PRCNC20240424

WESLEY HOMES BRADLEY PARK - PHASE 2
707 39TH AVENUE SE
PUYALLUP, WA 98374

ARCHITECTURAL SITE PLAN

A0.1

1 A0.1 **SITE PLAN - ARCHITECTURAL**
1" = 40'-0"

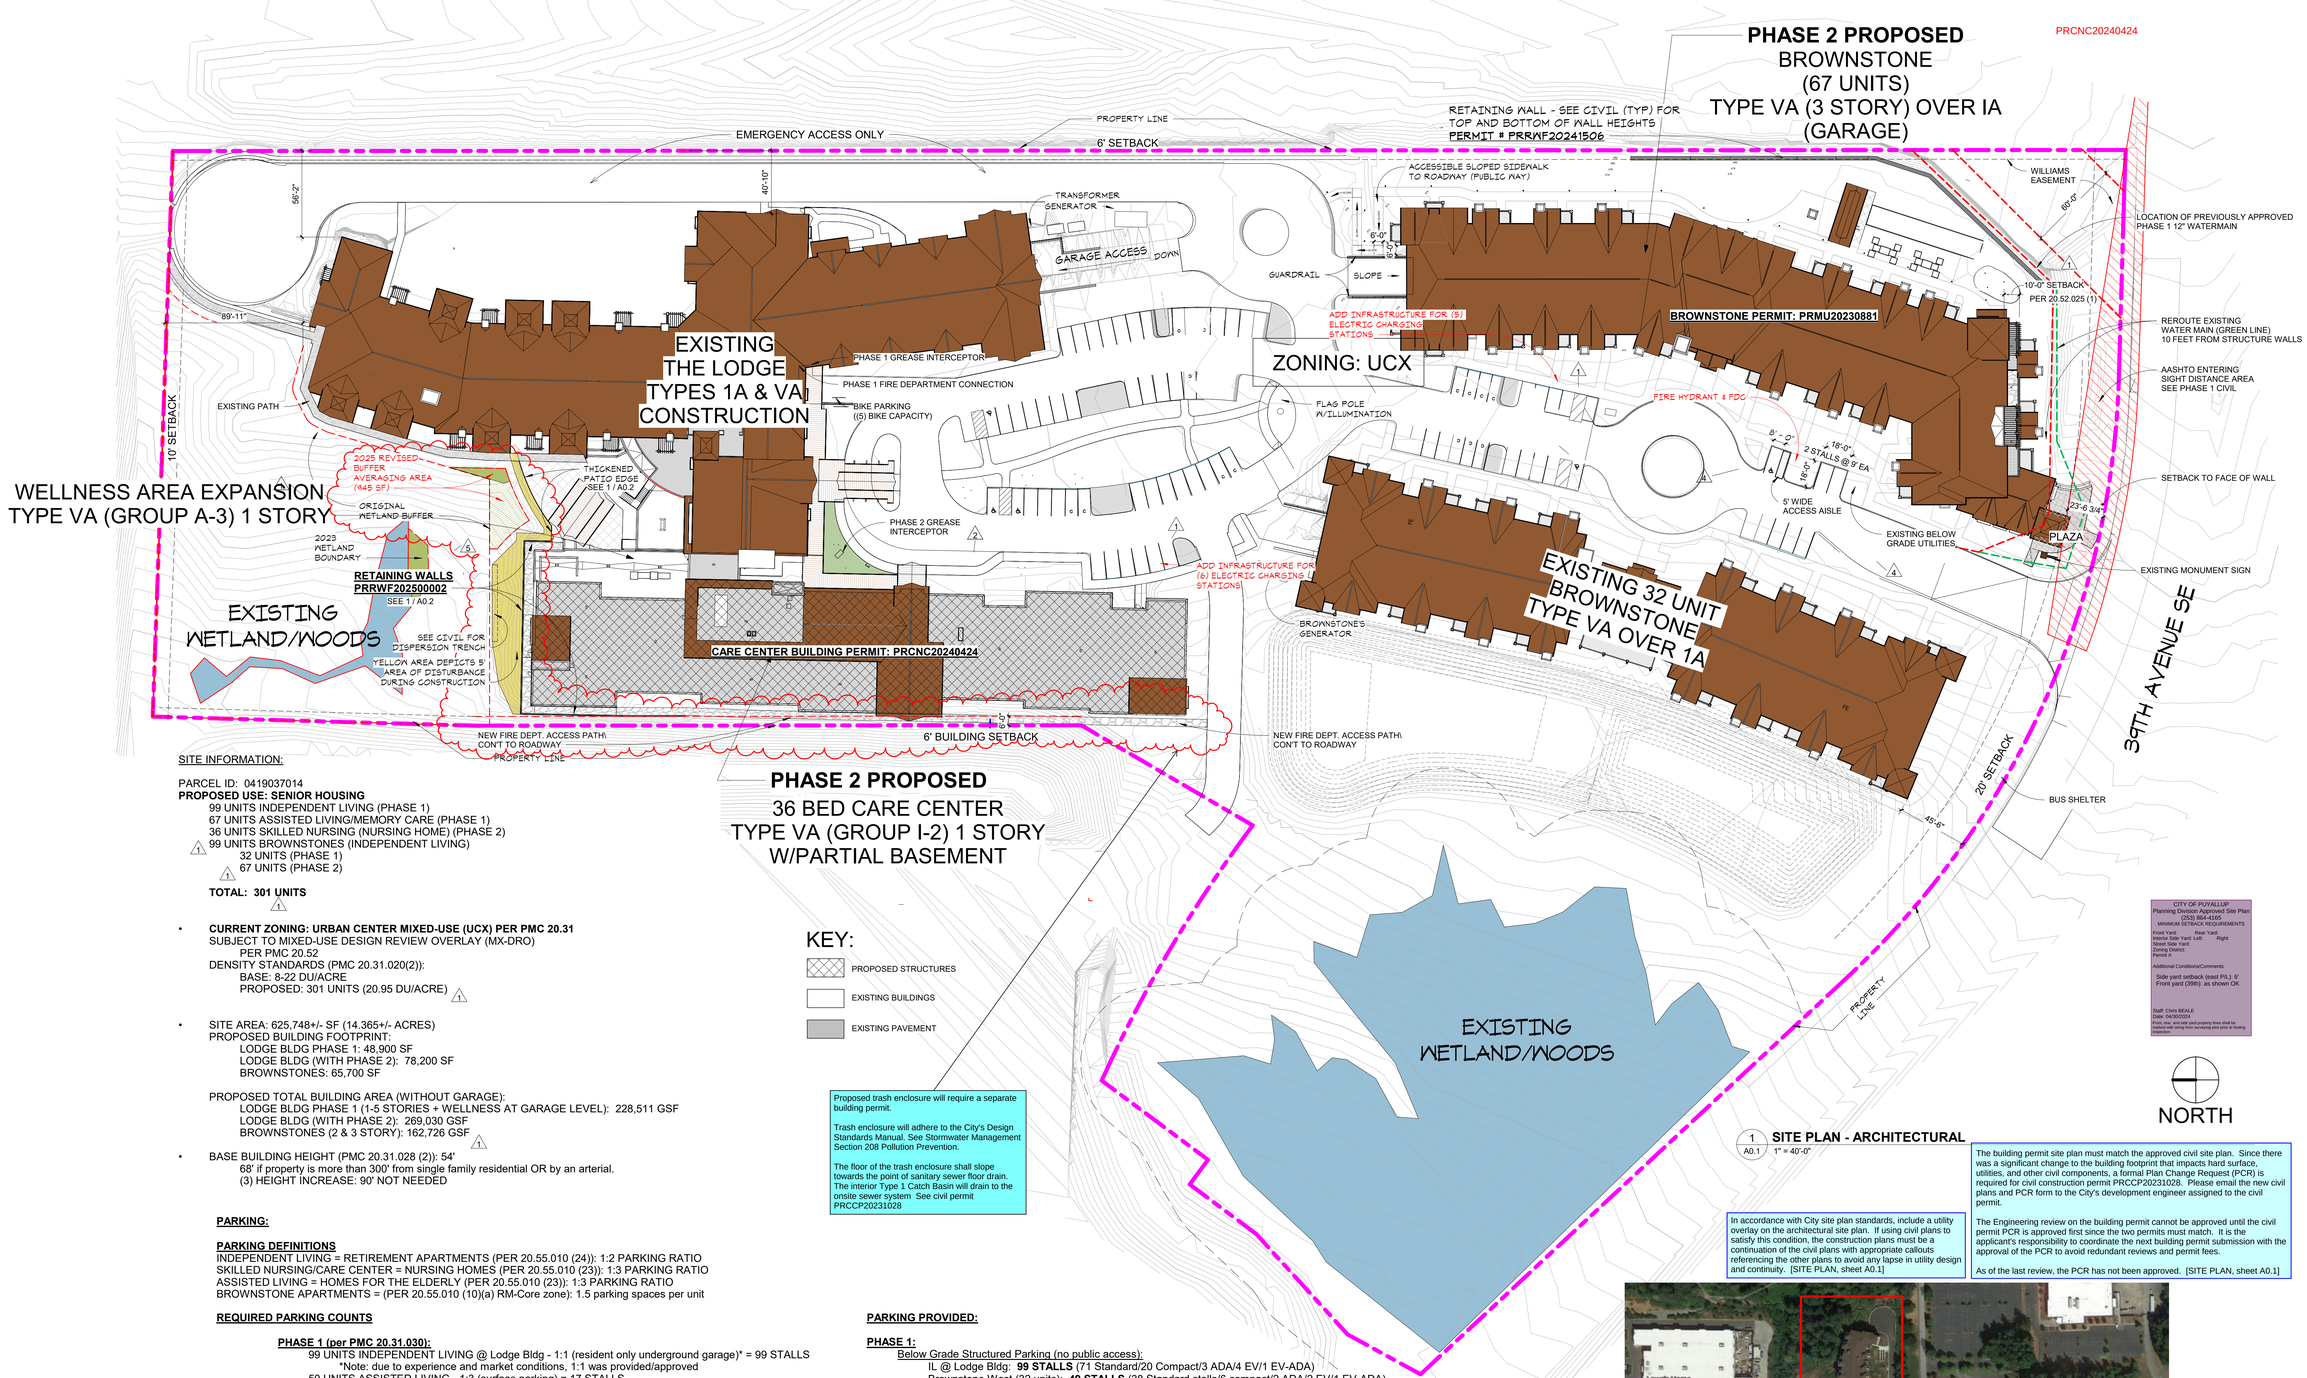
CITY OF PUYALLUP
Planning Division Approved Site Plan
(253) 864-4165
MINIMUM SETBACK REQUIREMENTS
Front Yard: Rear Yard:
Interior Side Yard: Left: Right:
Street Side Yard:
Zoning District:
Permit #:
Additional Conditions/Comments:
Side yard setback (east PIL): 8'
Front yard (39th): as shown OK.
Staff: Chris BEALE
Date: 04/30/2024
Front, rear, and side yard property lines shall be marked with string from surveying pins prior to footing inspection.

The building permit site plan must match the approved civil site plan. Since there was a significant change to the building footprint that impacts hard surface, utilities, and other civil components, a formal Plan Change Request (PCR) is required for civil construction permit PRCCP20231028. Please email the new civil plans and PCR form to the City's development engineer assigned to the civil permit.

The Engineering review on the building permit cannot be approved until the civil permit PCR is approved first since the two permits must match. It is the applicant's responsibility to coordinate the next building permit submission with the approval of the PCR to avoid redundant reviews and permit fees.

As of the last review, the PCR has not been approved. [SITE PLAN, sheet A0.1]

In accordance with City site plan standards, include a utility overlay on the architectural site plan. If using civil plans to satisfy this condition, the construction plans must be a continuation of the civil plans with appropriate callouts referencing the other plans to avoid any lapse in utility design and continuity. [SITE PLAN, sheet A0.1]
